# UNITED STATES PATENT AND TRADEMARK OFFICE

APPLICATION NO.	FILING DATE	FIRST NAMED INVENTOR	ATTORNEY DOCKET NO.	CONFIRMATION NO.
10/754,060	01/07/2004	Long-Sheng Liao	B-5346 621633-2	7692
36716	7590	04/06/2005	EXAMINER	
LADAS & PARRY 5670 WILSHIRE BOULEVARD, SUITE 2100 LOS ANGELES, CA 90036-5679			NGUYEN, THINH T	
			ART UNIT	PAPER NUMBER
			2818

**Office Action Summary**

**FIG 3D**

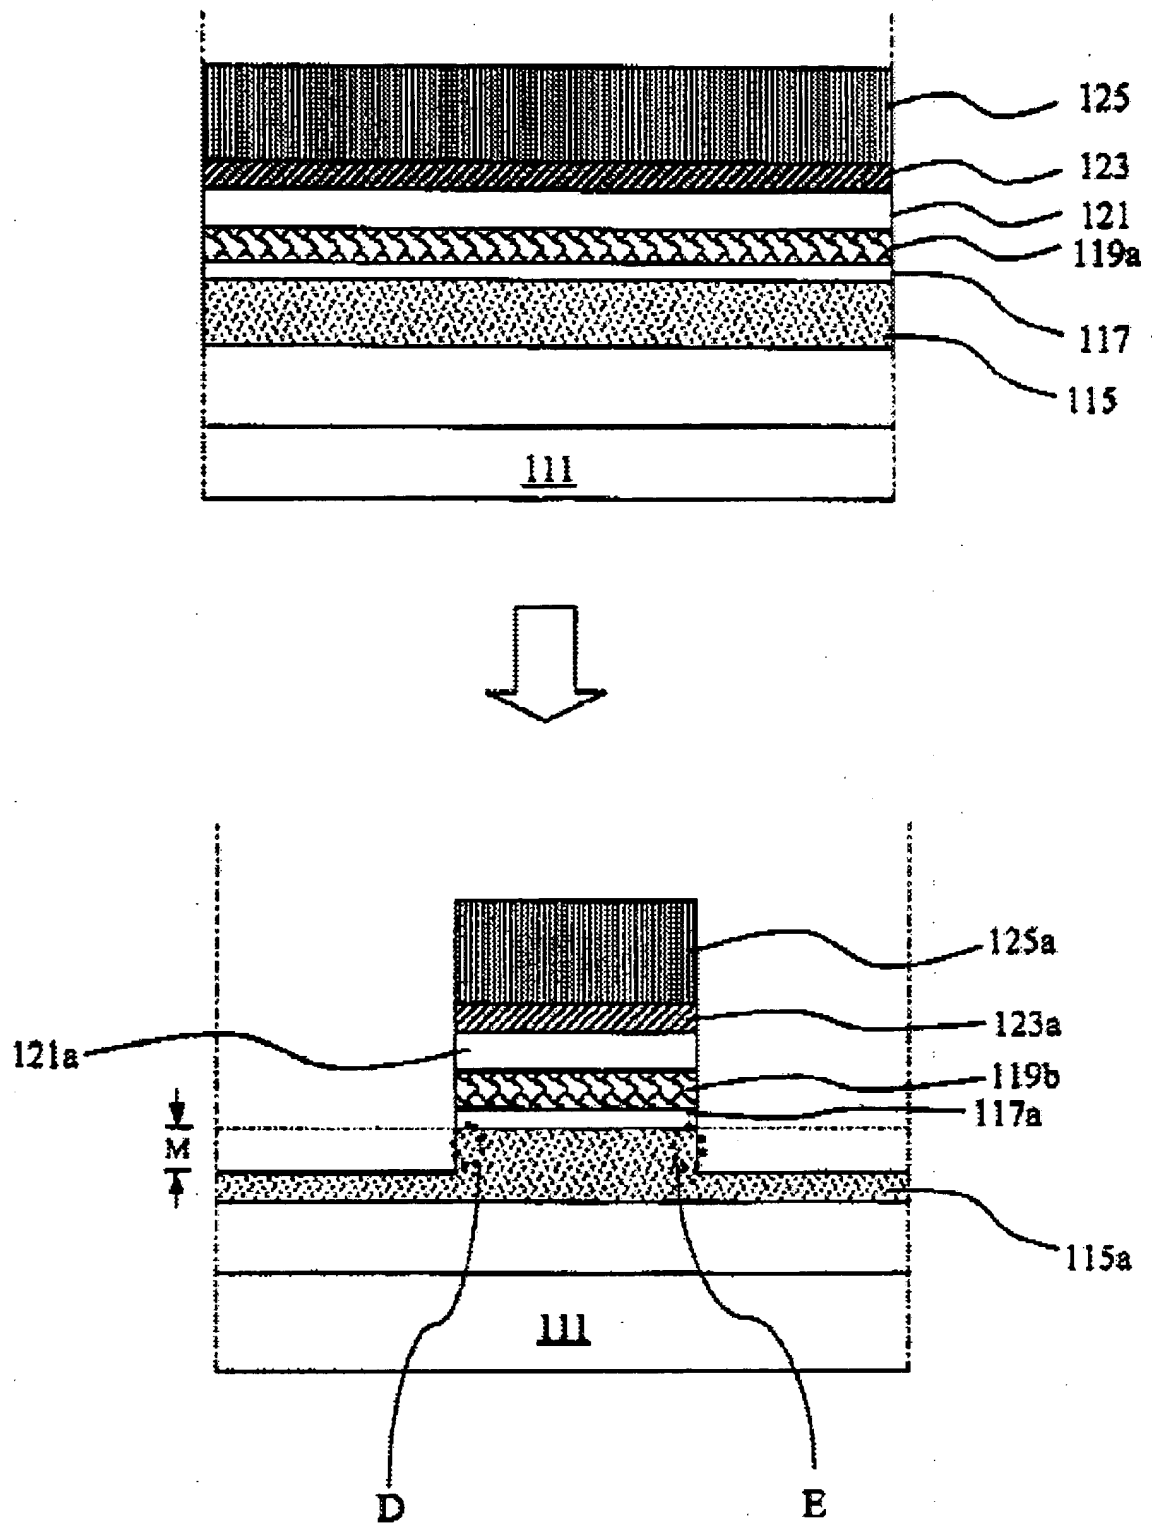
Park et al. disclose ( in the abstract, in fig 3D, fig 3E, column 4 line 10-12) a thin film transistor having a buffer layer for promoting electron mobility, comprising: a substrate ( fig 3D layer 111; a buffer layer, comprising: an amorphous layer ( fig 3D layer 115a), deposited on the substrate; and a crystallized layer ( layer 117a) , deposited on the amorphous layer; an active layer ( fig 3D layer 119b) ; deposited on the crystallized layer; an insulating layer (layer 121a, layer 117a), covered conformally on the active layer ,the amorphous layer, crystallized layer and the side walls of the active layer; a conductive layer( layer 123a ) , deposited on the insulating layer above parts of the active layer; and a dielectric layer ( layer 129), completely covering the crystallized layer and the conductive layer.

Park et al. disclose ( column 5 lines 60-62, fig 3) a silicon nitride layer 113 between the Substrate 111 and amorphous layer 115
